Product Change Notification - GBNG-17JHCL139

CCB 3893.004 and 3893.005 Final Notice: Qualification of an additional fabrication site (Microchip – Fab 5) for Die # 2 of selected Microsemi LCLD LE9642xx and LE9652xx device families available in 48L, 53L, 56L and 64L VQFN packages.

Pre and Post Change Fabrication Supplier / Location for Die # 2

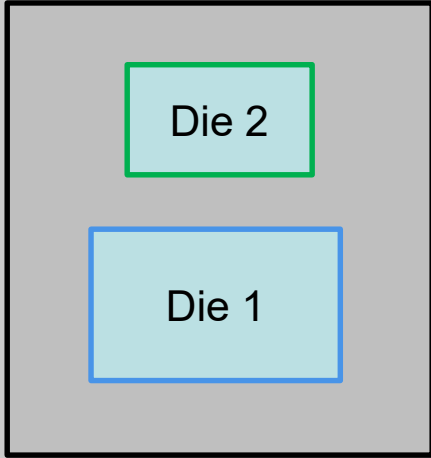
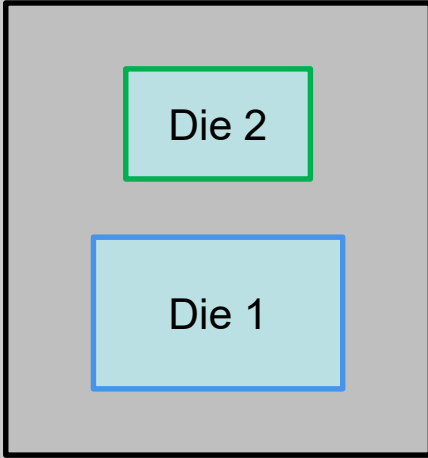
Pre-Change	Post-Change
<p>Fabrication Supplier / Location for Die # 2</p> <p><i>Note: No change for Die # 1</i></p>	<p>Die # 2 – Global Foundries, Singapore - Fab 2 (GF02)</p>  <p>Die # 1 – Global Foundries, Singapore - Fab 7 (GF07)</p>	<p>Die # 2 – Global Foundries, Singapore - Fab 2 (GF02) or Microchip Technology Colorado – Fab 5 (MCSO)</p>  <p>Die # 1 – Global Foundries, Singapore - Fab 7 (GF07)</p>
